7 Waterside Place, London, NW1 8JT

2022/4964/P

Delegated Report (Members Briefing)		Analysis sheet	Expiry Date:	17/02/2023
		N/A	Consultation Expiry Date:	05/02/2023
Officer			Application Number(s)	
Alex Kresovic			2022/4964/P	
Application Address			Drawing Numbers	
7 Waterside Place London NW1 8JT			Refer to Draft Decision Notice	
PO 3/4	Area Team Signature	C&UD	Authorised Officer Signature	
Proposal(s) Installation of 6 photovoltaic panels and 2 additional rooflights on the roof.				
Recommendation(s):		Grant Conditional Planning Permission		
Application Type:		Householder Application

Installation of 6 photovoltaic panels and 2 additional rooflights on the roof.

Figure 5: Proposed Roof Plan.

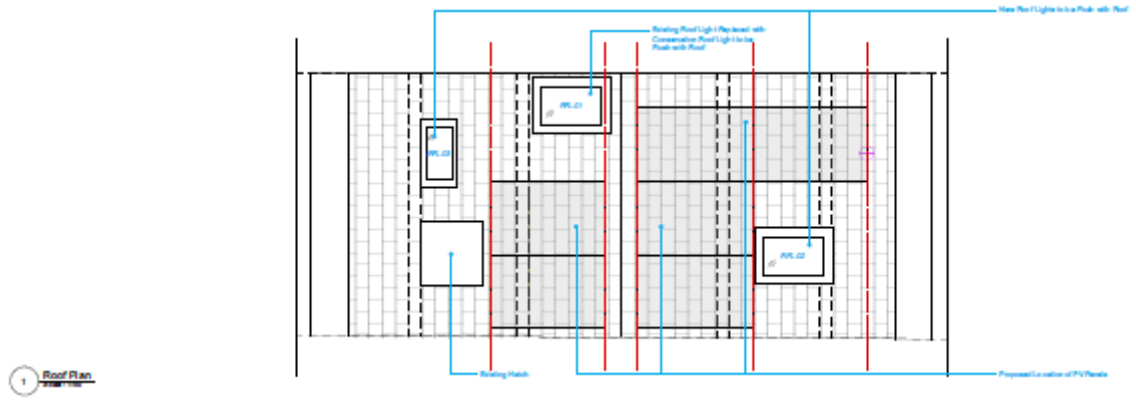
Conditions or Reasons for Refusal:	Refer to Draft Decision Notice			
Informatives:				
Consultations				
Adjoining Occupiers:	No. of responses	1	No. of objections	1
Summary of consultation responses:	<ul style="list-style-type: none">A press advert was published on 12/01/2023 (expiry 05/02/2023)A site notice was displayed on 11/01/2023 (expiry 04/02/2023)			
	<p>One (1) objection was received from Primrose Hill CAAC (PHCAAC), as summarised below:</p> <ul style="list-style-type: none">The PHCAAC is keen to support retrofitting in our conservation area which enables us to move towards a carbon-neutral environment while preserving and enhancing the character and appearance of the conservation area. This was the theme of the Open Day we held in November 2022, which was attended by 76 people. Officer's response: <i>Noted.</i>1-10 Waterside Place are categorised in the Primrose Hill Conservation Area Statement, the current SPD for the PHCA, at p. 18, as 'negative buildings' detracting from the character and appearance of the conservation area. We would comment that Waterside Place has good qualities, in particular its consistency and simple forms which provide a coherent pattern to the individual houses and to the houses as a group. Officer's response: <i>Noted.</i>The roof of the terrace, which forms a continuous surface not divided by party wall parapets, is a key part of the more positive elements of the group. While it is true that the roof has limited visibility from the Princess Road aspect, and none from the Canal towpath, it has considerable visibility in views from Gloucester Avenue, especially from the east side, from south and south-east, a view where the Waterside Place terrace forms a visual boundary to the Canal. Officer's response: <i>The proposed works are considered to have minimal visibility from the streetscape, which would contribute to no harm to the conservation area.</i>The PHCAAC's concern is that the formally acknowledged negative qualities of Waterside Place should not be exacerbated – cumulative harm to the character and appearance of the conservation area – and the positive aspects of coherence and consistency enhanced. Officer's response: <i>Noted.</i>We object to the present layout of the PV panels and the rooflights which are visually incoherent, but which could be regularised and consistent in terms of alignment and location. We would also seek to move the PV panels lower down the roof slope from the ridge. We also suggest that roof-integrated PV panels could minimise impact on the conservation area and enhance the appearance of the installation. Officer's response: <i>Please see the below satellite image highlighting the existing inconsistent layout of rooflights and hatches on the roofscape, which are not seen from street level.</i>

It is however not possible to move the PV panels down the roof due to the limited size of the roof, and existing location of the hatch. It is reiterated that the angle of view from any point in the surrounding area, including Gloucester Avenue, is too acute to provide a view of the roofscape of Waterside Place. Therefore, the panels will barely be visible, if at all.

- The decision on this application will have important implications in precedent for the rest of the terrace: a set of alignments which would enhance the good qualities of the Waterside Place terrace.

3.3 The positioning of the PV panels once submitted were very erratic in terms of design and appearance from Gloucester Avenue Bridge, along the rear elevation. However, the position of the PV panels on the rear elevation have slightly been altered during the process of the application to be in a more regularised manner, creating an ordered grid which could then be repeated along other houses in the terrace without adversely impacting the conservation area.

Officer's response: *The positioning of the PV panels has been amended to be in a more regularised manner, creating an ordered grid which could then be repeated along other houses in the terrace without adversely impacting the conservation area.*
